ISO/IEC JTC 1/SC 17
Cards and personal identification
Secretariat: BSI (United Kingdom)

Document type: Disposition of Comments Report

Title: Disposition of comments: FCD ISO/IEC 14443-3:2010/FDAM4 — Identification cards - Contactless integrated circuit(s) cards — Proximity cards — Part 3: Initialization and anticollision — AMENDMENT 4: Electromagnetic disturbance handling and single size UID

**Disposition of comments on:
FCD ISO/IEC 14443-3:2010/FDAM4 — Identification cards —
Contactless integrated circuit(s) cards — Proximity cards — Part 3:
Initialization and anticollision — AMENDMENT 4: Electromagnetic
disturbance handling and single size UID**

Figure 1 — Frame delay time PCD to PICC

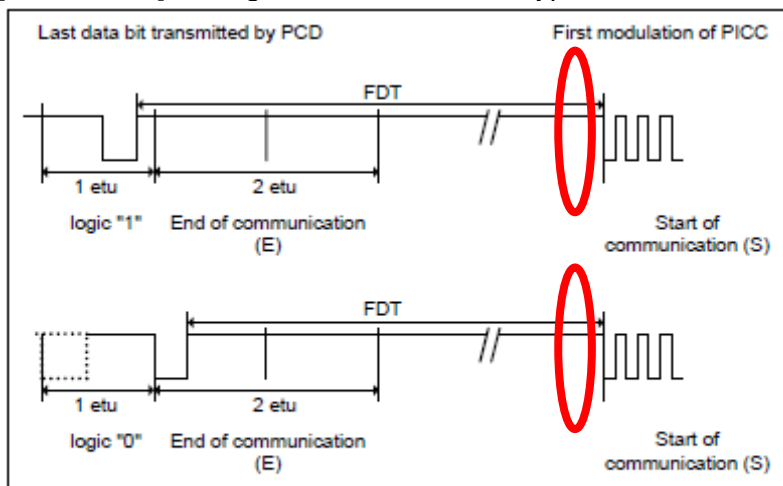
JP3	6.2.1.1 and 7.1.6	Figures and 17	1 ED	For better understanding the relation between (FDT/TR0) and ($t_{E,PICC}$ and $t_{E,PCD}$).	Update the Figures 1 and 17 of ISO/IEC 14443-3:2010 by inserting $t_{E,PICC}$ and $t_{E,PCD}$ (See the solid circles in JP Annex-1 and JP Annex-2). Insert the following NOTE after these Figures; "For $t_{E,PICC}$ / $t_{E,PCD}$, see 8.1."	Resolved by Replacing figures 1 and 17 including illustrations of $t_{E,PICC}$ from tepicc.vsd and adding the note after these figures
JP4	6.5.4	Table 1	ed	Table number is mistaken..	Replace "Table 1" by "Table 11".	Resolved by UK
JP5	6.5.4	Table 1	ed	This clause is revising Table 11 and is not one about EMD handling.	Add Note after the Table.	Resolved by changing the title
